Lake Auburn Watershed Protection Commission

*Date: June 24, 2022 (Draft)
October 5, 2022 (Revised)*

Figure ES-1: Summary of Estimated Watershed Boundary Review

CEI Draft Peer Review of FB Environmental Study

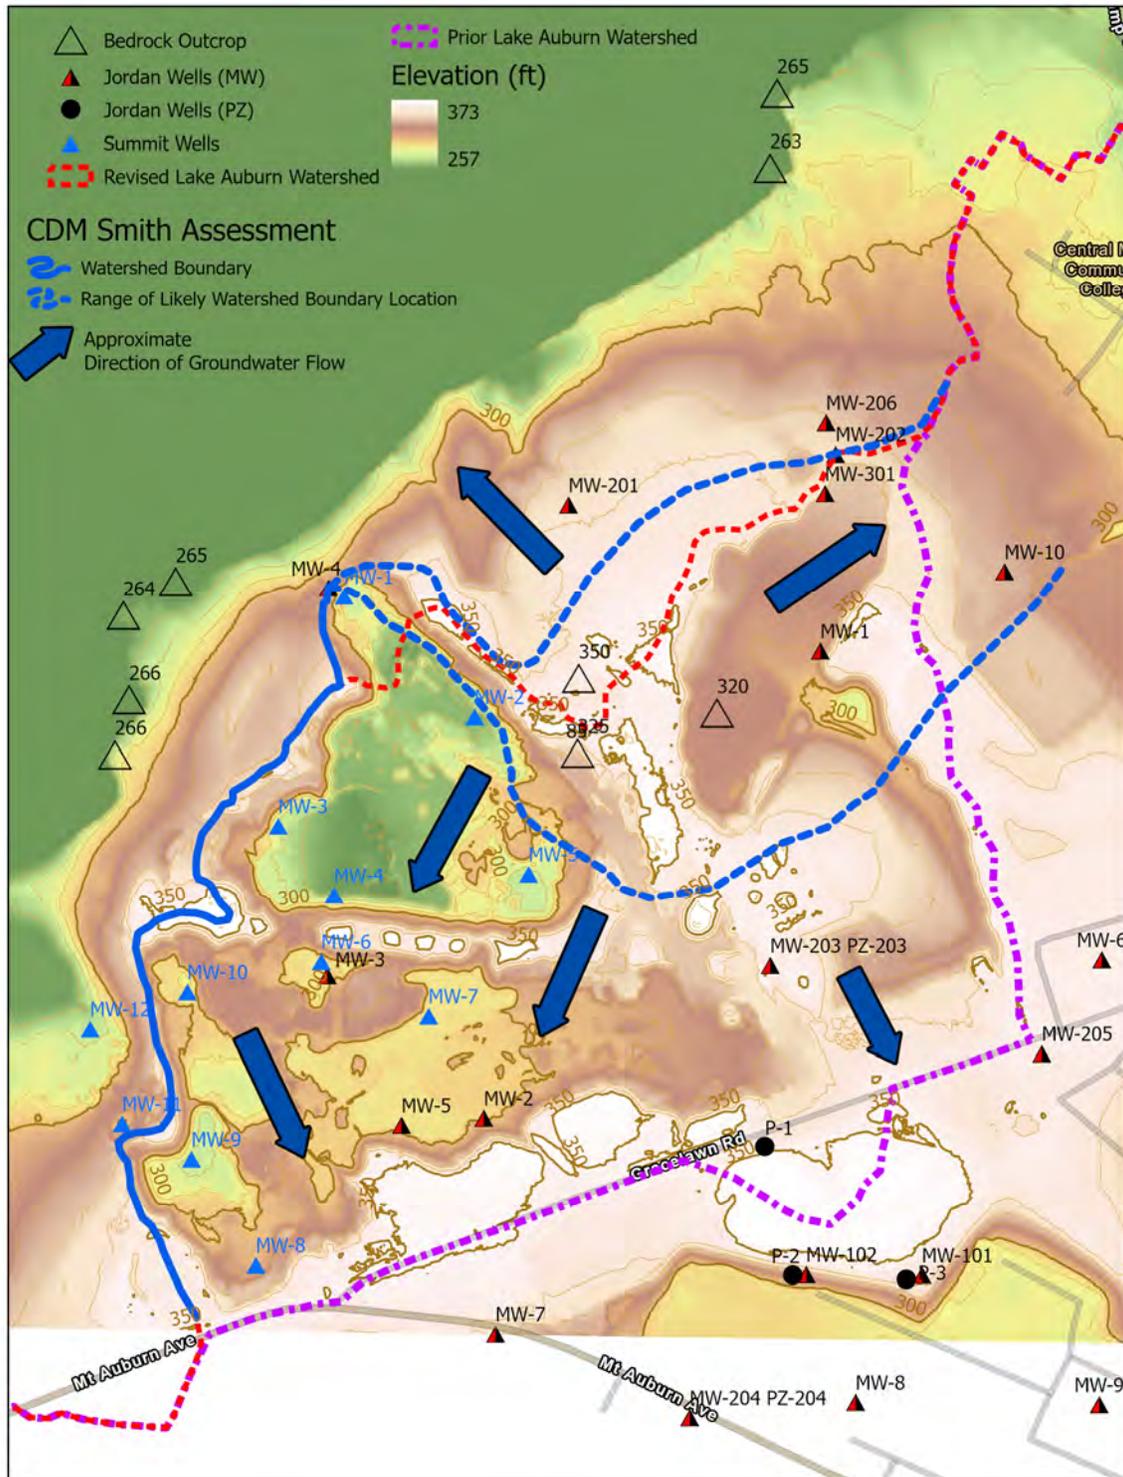
Based on CDM Smith's review, the groundwater data support the revised watershed delineation in some areas, and in other areas the data are insufficient to confirm a precise delineation. **Figure ES-1** presents a summary of the review, including the revised delineation (red dashed line), the area of uncertainty (blue dashed line) and direction of groundwater flow (blue arrows), and can be summarized as follows:

- The solid blue line to the west is a delineation that reflects surface topography and is consistent with the FB Environmental revised delineation except for a small area to the north near MW-1 and MW-4. To the south of this line, data from 14 groundwater monitoring wells indicate flow in the surficial sand and gravel away from the lake and, significantly, groundwater levels that are below lake level, precluding discharge to the lake.
- Near the center of **Figure ES-1** are three triangles indicating the location and elevation of bedrock outcrops. In this area of high bedrock (so called "bedrock knob"), the water table is

in bedrock and is above lake level based on surrounding well data. However, in the reviewed reports there is no well data to indicate bedrock flow direction in this area. Hence, **Figure ES-1** indicates a band of uncertainty in the area of the outcrops and nearby topographic high elevations.

- To the east of the bedrock knob, water level data from wells MW-1, MW-10, MW-301 and MW-206 indicate a water table in the sand and gravel above lake level with a generally northeastward flow direction. Groundwater within the band of uncertainty in this area could possibly discharge to Lake Auburn or to a stream farther to the east that is tributary to the Androscoggin River.
- The northern limit of the uncertainty band in **Figure ES-1** is approximately consistent with a surface drainage divide indicated by topography. To the south of the uncertainty band, water level data (and also water quality data) indicate that the water table is in the surficial sand and gravel with a flow direction away from the lake. This includes data from wells MW/PZ-203, P-1, MW-205, MW-102/P-2 and MW-101/P-3.

Figure 1 Previous (black dashed) and revised (blue) watershed delineation per FP Environmental (2021)

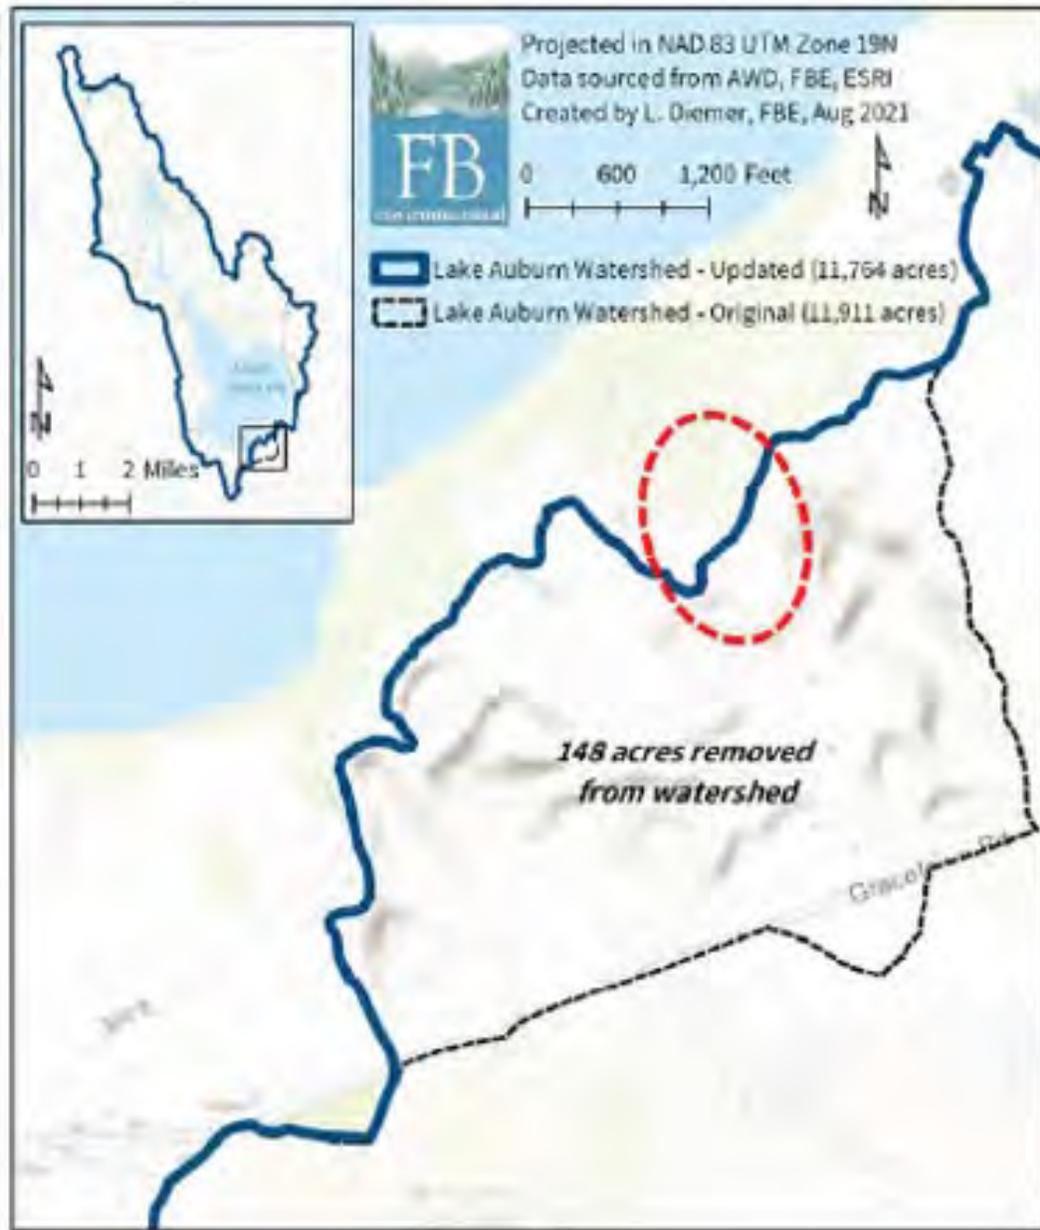
The watershed delineation was moved northward, closer to the lake, removing approximately 148 acres from the estimated watershed. **Figure 1** shows the previous and revised delineations as presented by FB Environmental. **Figure 2** shows an approximation of these delineations sketched onto an aerial photo. The area between the old and proposed new delineations includes a number of sand and gravel borrow areas on the west side and former City of Auburn landfill and dump areas to the southeast

As part of an environmental and regulatory analysis of Lake Auburn water supply protection (FB Environmental, 2021), a revised watershed delineation of the watershed near the southeast shore of the lake was presented which reduced the watershed area by 148 acres (**Figure 1**).

Figure 4 Topography

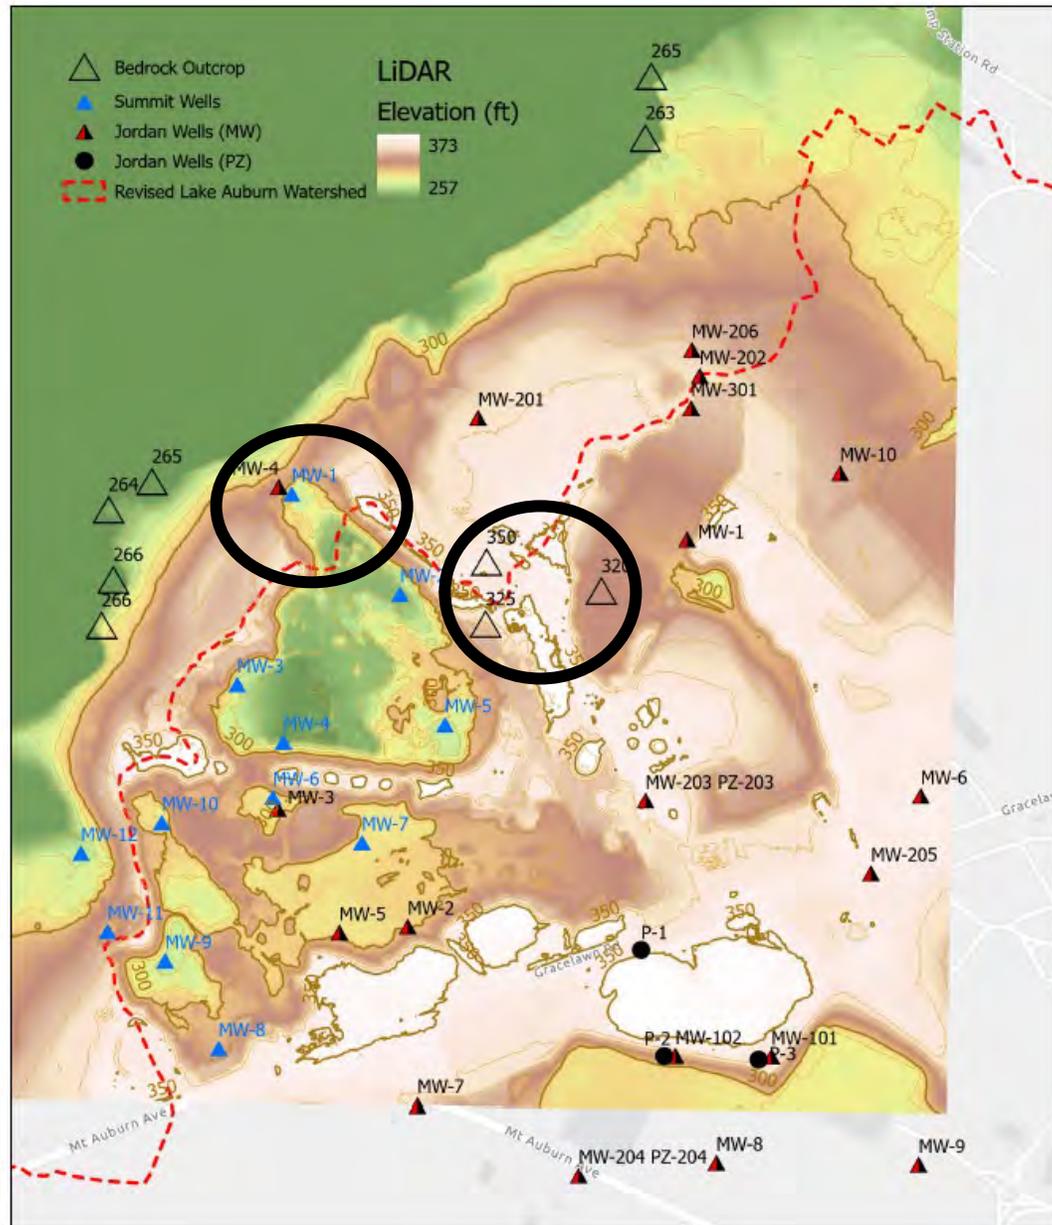
Topography and surface water drainage were not addressed in the reports reviewed for this memorandum. However, it is evident in **Figure 4** that topography was a significant factor in developing the revised watershed delineation. That is, the revised delineation in large part follows local topographic high points. Apparent exceptions are circled in **Figure 4**. The delineation does not follow the topographic high to the north near Summit well MW-1 and Jordan well MW-4, and

Figure 5 Bedrock surface contour map from E.C. Jordan (1990)

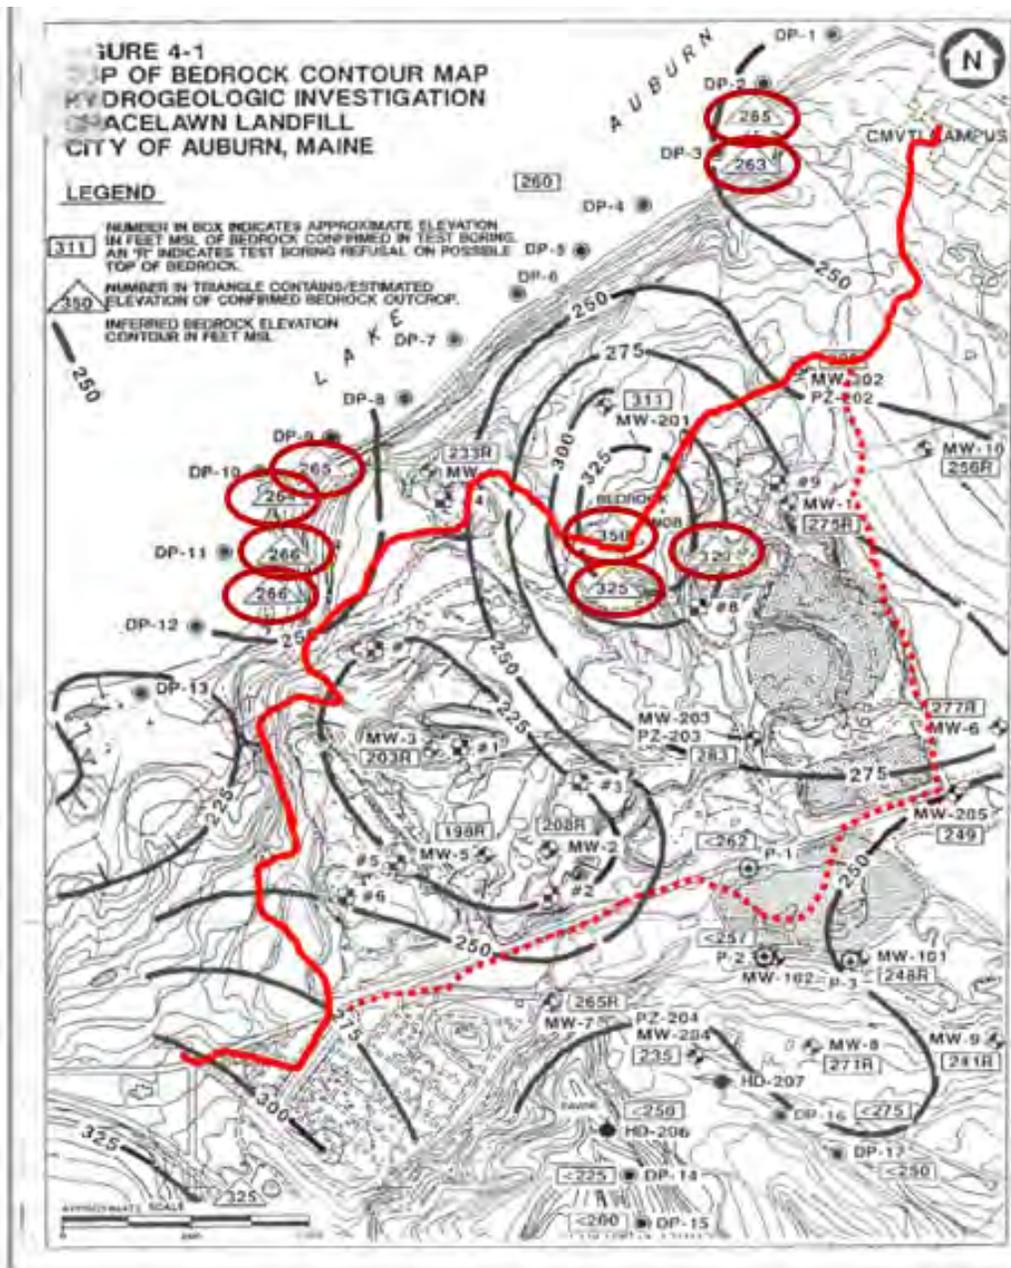
Figures 5 and 6 show bedrock surface contours as presented by E.C. Jordan (1990) and Woodard and Curran (1995), respectively. In **Figure 6**, bedrock surface contours are shown only for the northeast part of the study area (orange circle). Seismic survey lines in that area are also shown. The contours in both figures were developed based on seismic surveys, boring logs and surveyed elevations of outcrops. Though it is not stated how the thin till layer might affect the seismic data and refusal in borings, the delineated bedrock surface should be reasonably representative of the bottom of the sand and gravel overburden aquifer, except at the identified outcrops areas where the overburden aquifer does not exist.

- Near the center of the study area is an area of high bedrock, labeled “bedrock knob” in **Figure 5**. The area includes outcrops, indicated by triangles in the original figure, circled in red in **Figure 5**. Outcrop surface elevations of 350, 325 and 320 feet mean sea level (MSL) are shown. The reported bedrock surface at MW-201, just north of the outcrops, is also greater than 300 feet.
- The bedrock surface appears to decline most steeply from the “knob” area to the north and northwest towards the lake, and to the southwest.

Figure 6 Bedrock surface contours from Woodward & Curran (1995)

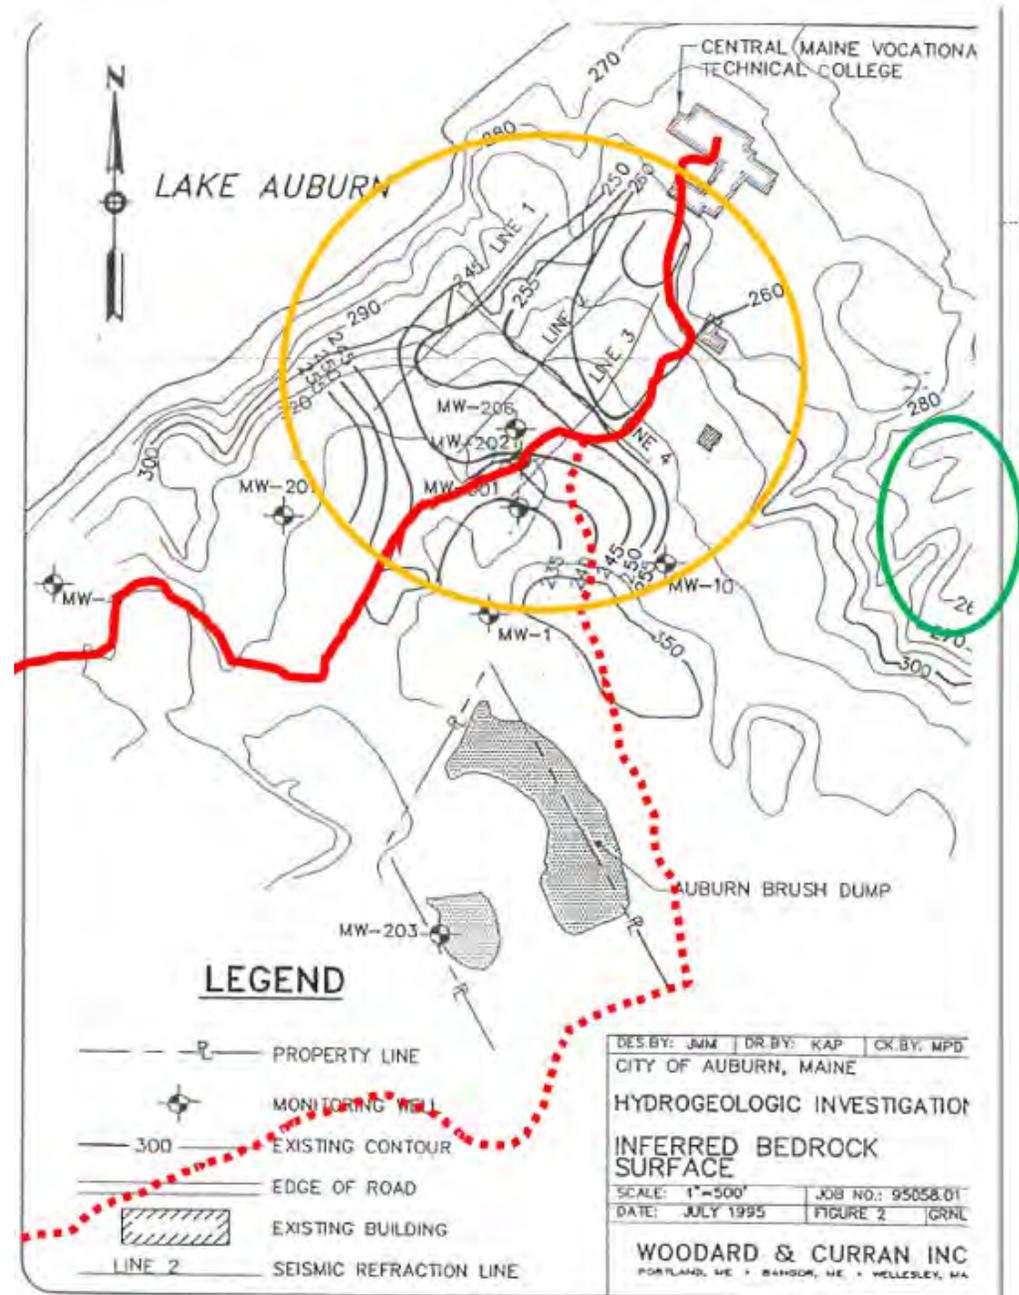
- **Figure 6** shows bedrock surface elevation contours for this area presented by Woodard and Curran (1995). These are based on boring logs and the seismic survey. The contours indicate the bedrock surface is lower than 250 (and as low as 235) feet MSL at MW-202, MW-206 and MW-301, approximately 900 feet east of the knob, indicating a significant decline.
- The contours indicate a subsequent rise in the bedrock surface to elevations greater than 260 feet MSL farther to the northeast.

- Note that the contouring shown in **Figure 6** does not account for the higher bedrock surface estimated at MW-1, approximately 500 feet south of MW-301, to be 275 feet MSL.
- The green circle at the eastern edge of **Figure 6** highlights locations where the topographic contours indicate areas where the ground surface is less than 260 feet. The area is highlighted in **Figure 6** because subsequent figures in this report do not extend that far to the east.

Figure 12 Study area monitoring wells and zoning

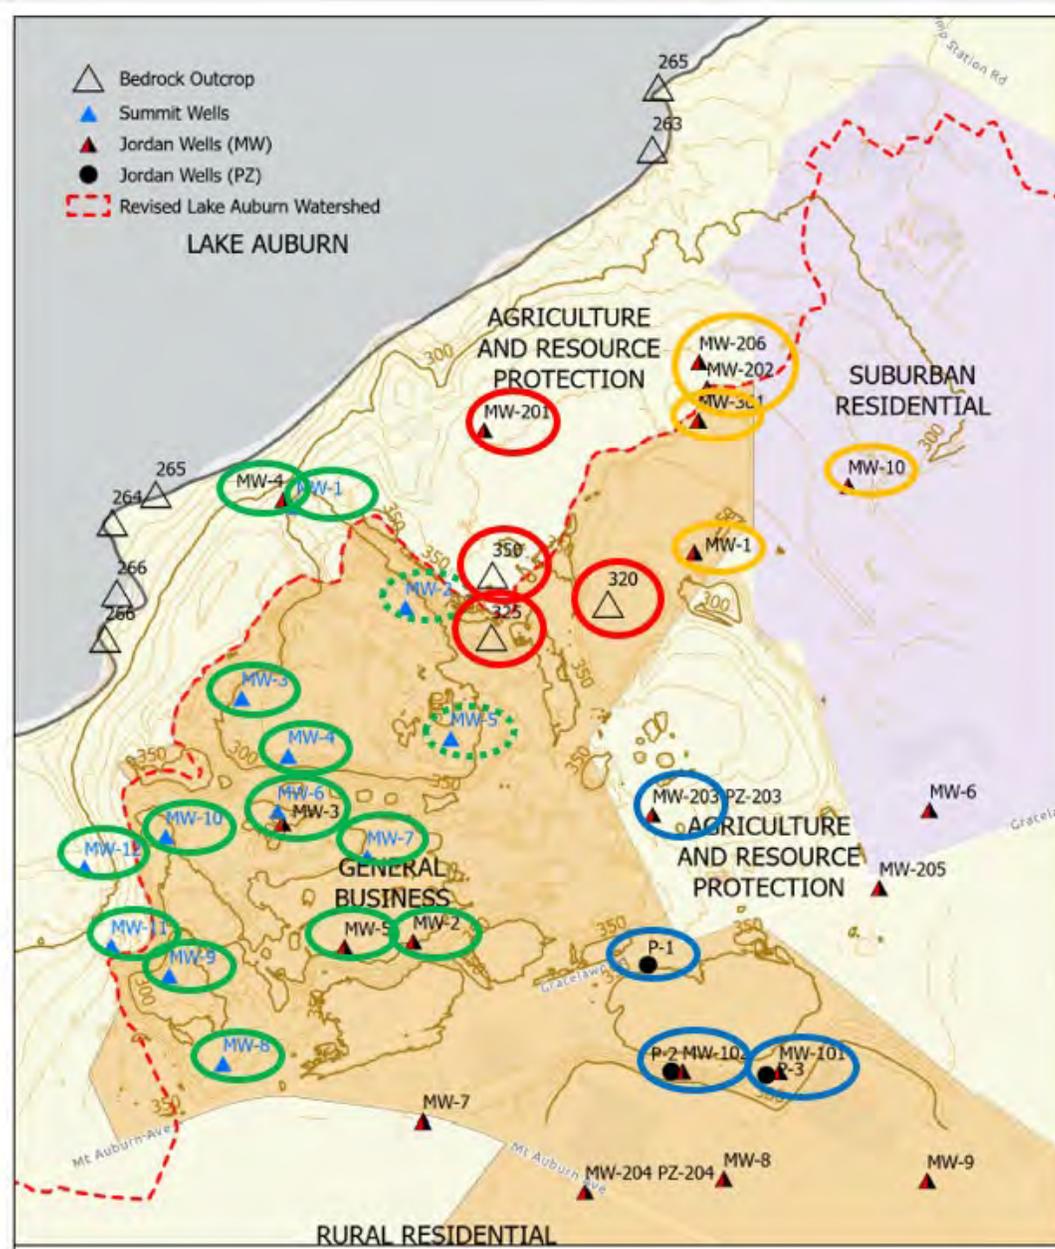
Near the center of the area where the watershed delineation has been revised (study area), the bedrock surface rises, creating what is called a bedrock "knob". Groundwater flow here occurs only in bedrock. The bedrock groundwater level well MW-201 in this subarea is more than 40 feet above the lake surface water level and the groundwater level could be higher still near the bedrock outcrops farther to the south. Well MW-201 and the outcrops are circled in red in **Figure 12**.

There are insufficient data to reliably determine bedrock aquifer flow directions, but it would be reasonable to extend the revised watershed farther south in this area, to at least include the observed outcrop areas where the bedrock aquifer would be directly recharged as well as the nearby topographic high.

To the west and southwest of the bedrock knob is a subarea represented by 14 monitoring wells (solid green circles in **Figure 12**) where the overburden groundwater level measurements are consistently below the lake surface water level. Groundwater in the area represented by these wells does not discharge to the lake. This is consistent with the revised watershed delineation, except that two of the wells in this group are north of the revised watershed delineation as shown in **Figure 12**.

Summit Environmental well MW-2 and MW-5 (Dashed green circles in **Figure 12**) are likely near the limit of the west-southwest subarea where groundwater flow is predictably away from the lake. Just to the northeast of these wells the ground surface and bedrock surface rise steeply towards the knob area.

The previous watershed delineation apparently included the Gracelawn Landfill near its southeastern limit. Groundwater level and water quality data at wells circled in blue in **Figure 12** indicate that groundwater flow in this vicinity is southward, away from the lake. This is consistent with the revised watershed delineation.

Groundwater in the area indicated by the orange circled wells east of the knob in **Figure 12** likely flows in part to Lake Auburn and in part to a small stream just east of the study area that is ultimately tributary to the Androscoggin River. Data in the review documents, are not sufficient to precisely locate the divide between groundwater flow to the lake and to the river, and thereby establish a precise watershed boundary.
